American Council for an Energy-Efficient Economy
Appliance Standards Awareness Project
Natural Resources Defense Council

**RE: Docket Number EERE–2013–BT–STD–0030/ RIN 1904–AD01: Preliminary
Technical Support Document for Commercial Packaged Boilers**

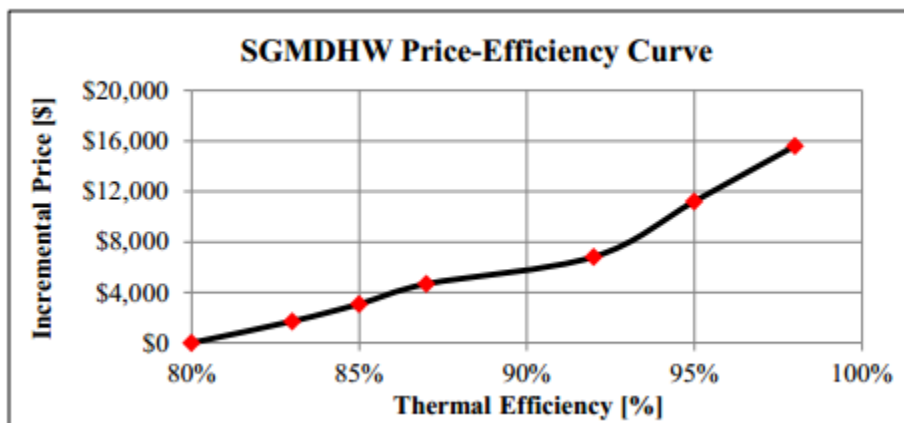
Another example that raises questions about the overall accuracy of the price analysis is related to the slope and inflection points of the efficiency curve for small gas-fired, mechanical draft hot water boilers. DOE notes in the preliminary TSD that there is generally a step change in price from a non-condensing boiler to a condensing boiler.⁶ While this statement seems logical, it is inconsistent with the price efficiency curve for small gas-fired, mechanical draft hot water boilers presented in the preliminary TSD and shown below.⁷ For this equipment class, the slope of the price-efficiency curve going from the highest non-condensing level (87% thermal efficiency) to the lowest condensing level (92% thermal efficiency) is actually *lower* than the slope of both the non-condensing and condensing portions of the price-efficiency curve. There does not appear to be any explanation in the preliminary TSD for the reduced cost increment going from a non-condensing to a condensing level, which reduces our confidence in the price data overall.

We encourage DOE to collect additional price data including through interviews with and surveys of those who write specifications (consulting engineers and others) and those who bid on projects (mechanical contractors). DOE may also be able to obtain data on commercial boiler purchases by the Federal government. For the collected price data, we urge DOE to ensure that these data reflect the prices that customers are actually paying as opposed to “list” prices that are widely discounted in actual bids. We also urge DOE to ensure that the estimates of incremental prices only include the incremental price associated with the technology options required to meet a given efficiency level, and do not include the cost of auxiliary options that are often associated with premium products but are not associated with efficiency. For example, since the current test
